**BEFORE THE
ARKANSAS PUBLIC SERVICE COMMISSION**

**IN THE MATTER OF SOUTHWESTERN)
ELECTRIC POWER COMPANY'S)
PETITION FOR A DECLARATORY)
ORDER FINDING THAT)
INSTALLATION OF ENVIRONMENTAL)
CONTROLS AT THE FLINT CREEK)
POWER PLANT IS IN THE PUBLIC)
INTEREST**

DOCKET NO. 12-008-U

**REPLY TESTIMONY
OF
RICHARD S. HAHN
ON BEHALF OF THE GENERAL STAFF OF THE
ARKANSAS PUBLIC SERVICE COMMISSION**

Figure 1

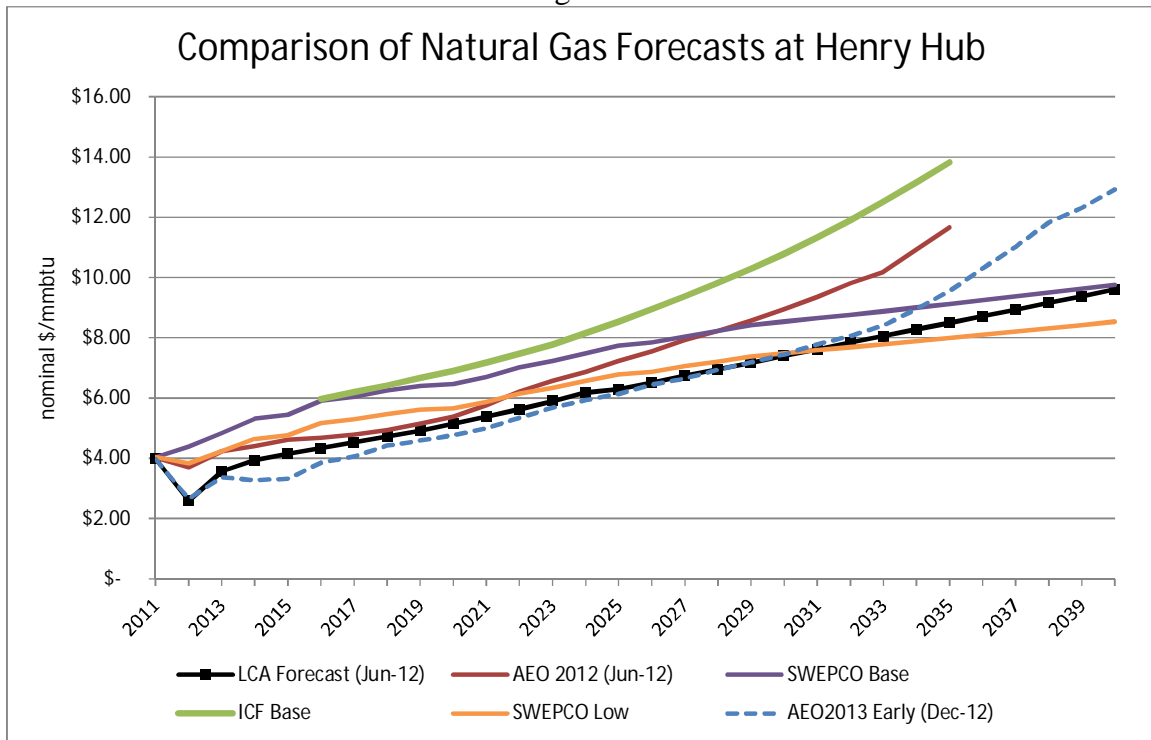
7 A. The Production Tax Credit ("PTC") has been extended and the Energy
8 Information Administration's ("EIA") latest independent forecast of natural gas
9 prices, cited as a reliable source by the Applicants, has fallen significantly. In its
10 analysis, SWEPCO assumed that the PTC would be eliminated. Figure 1 below,
11 provides a comparison of the natural gas price forecast that were used in this
12 proceeding. This comparison also includes the EIA's latest Annual Energy
13 Outlook ("AEO") early release forecast for natural gas prices, which was made
14 available in December 2012. As shown in Figure 1, natural gas prices are forecast
15 to be even lower than the forecast I used in my analysis and in the analysis
16 prepared by SWEPCO provided in response to APSC 010-1.

2 A. All options evaluated are economically within a close range. With the approval of
 3 the PTC and the decline in the natural gas price forecast the gas options continue
 4 to evaluate favorably compared to the retrofit option. Consistent with my
 5 Surrebuttal Testimony, it is important to consider not only the results of the
 6 economic analysis, but also, a broader decision framework.²⁰ My assessment of
 7 the economic analyses has not changed. However, the risk and uncertainty
 8 associated with the results of the reliability analysis and the timing associated
 9 with compliance with MATS appear to favor the retrofit of Flint Creek.
